ADDENDA NO. 1

SEWER PUMP STATION RENOVATIONS MORGAN CITY HOUSING AUTHORITY

DATE ISSUED: January 30, 2008
BID DATE: February 7, 2008

EES PROJECT NO. 0739

TYPE F-2
 GRANULAR EMBEDMENT
 THERMOSET PIPES

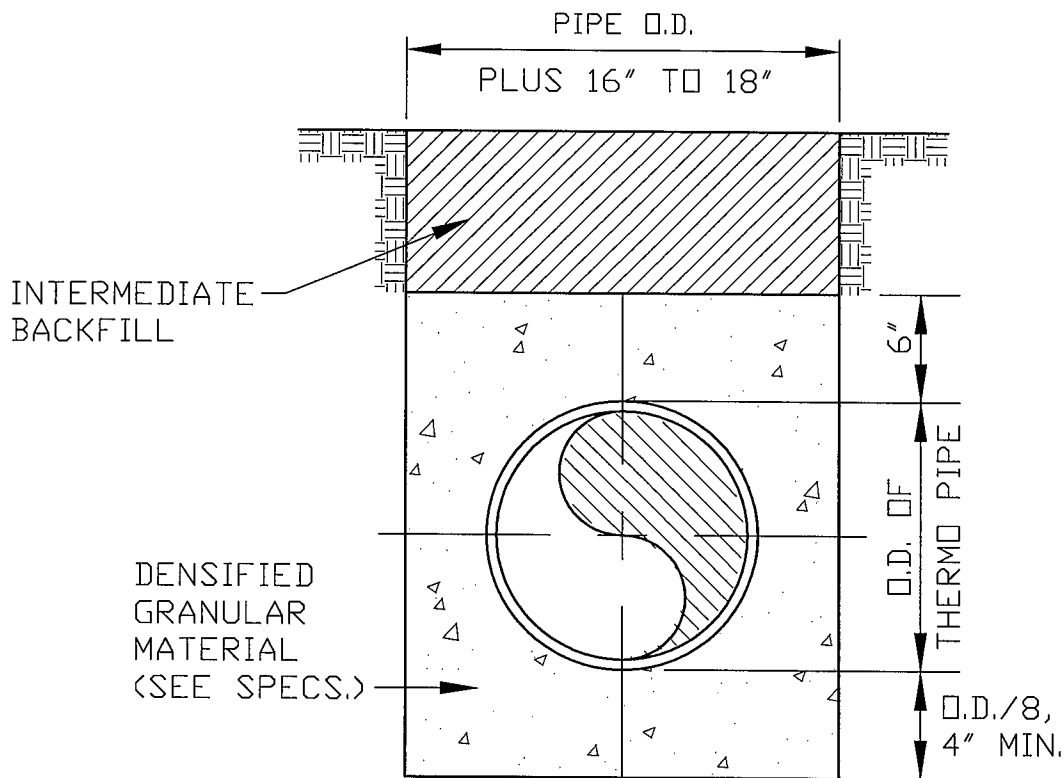
Remove the detail titled Type F-2/Flexible Sewer Embedment and **Replace** it with the attached detail titled Type F-2/Flexible Sewer Embedment Addendum No. 1.
